ADDENDUM #1

211-231 BANK STREET CONSERVATION PLAN

Applications D02-02-22-0127 / D07-12-22-0188 and plan number 18910

1.1 Introduction

Figure 2: SF-1 Conceptual façade support section. Source Art Engineering Inc. August 24.

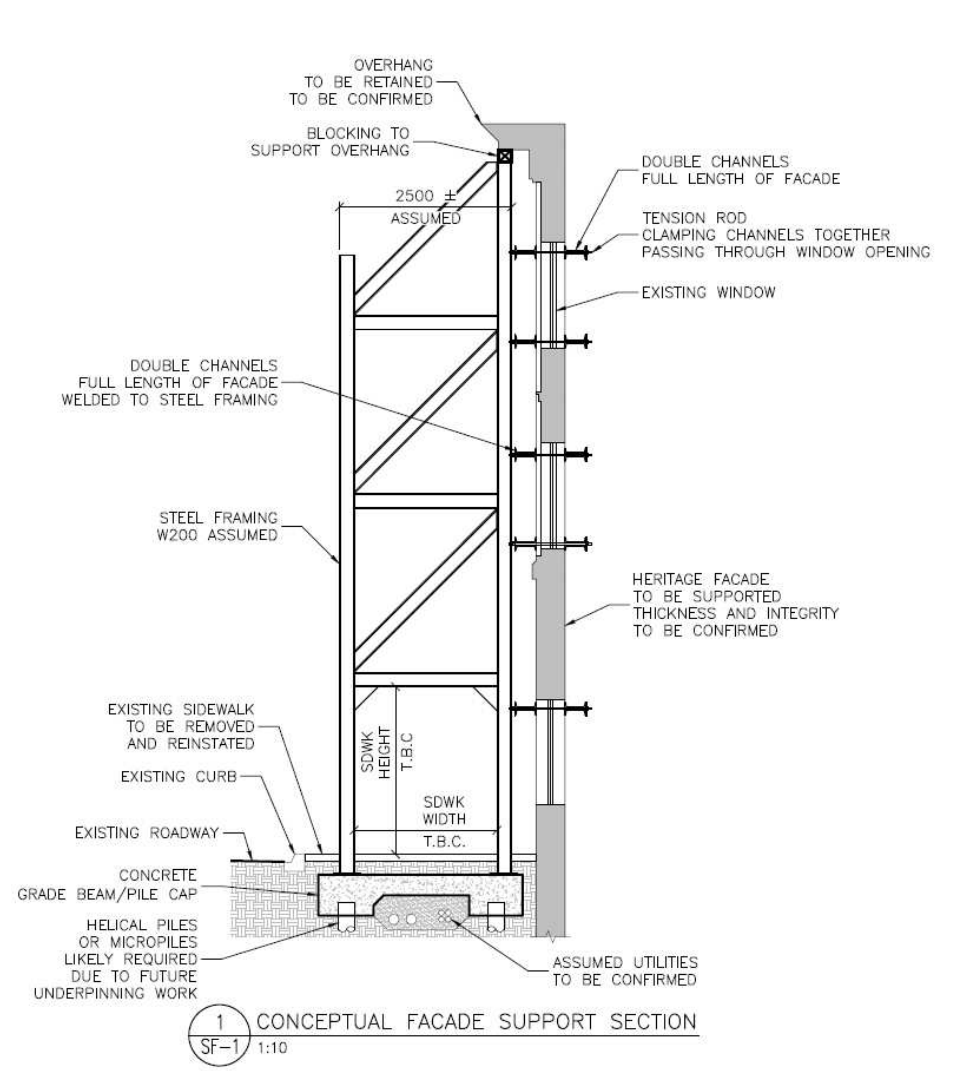
- *Maintain the existing pattern of recessed entrances. Recessed entrances are an important attribute along Bank Street to retain the rhythm and character of the streetscape.*
- *Limit the third-floor terrace to the Nepean façade. Remove the portion overlooking Bank Street, as rooftop terraces are not common within the Centretown HCD.*
- *Consider the removal of the cinder block wall on the Nepean façade, or alternatively, install a mural as proposed in the Conservation Plan.*
- *Consider improvements to the Nepean façade through the replacement of the altered windows, shown in the image below. For consistency, and a historically appropriate window style, replace any non-traditional styles with one-over-one windows. The Conservation Plan indicates that all windows will be replaced with new units, however the elevations and renderings show the existing windows in the proposal.*

Art Engineering Ltd., a structural engineer licenced in Ontario with a background in masonry conservation, is contracted to prepare specifications for masonry conservation and for the structural shoring specifications. It will outline a strategy and provide direction, ensuring temporary shoring to support the heritage façades with bracing erected on the exterior façade along the street. Art Engineering will provide a detail description of the methodology for shoring the existing buildings from the exterior in the design phase.

The temporary shoring plan and masonry restoration addresses the existing exterior masonry on the first, second, and third storeys of the existing buildings at 211, 215, 219 223, and 231 Bank Street as well as the extensions along 178 Nepean and Lisgar Streets. Portions of the rear façade are being demolished and brick will be salvaged for use in repairs and infill with matching material.
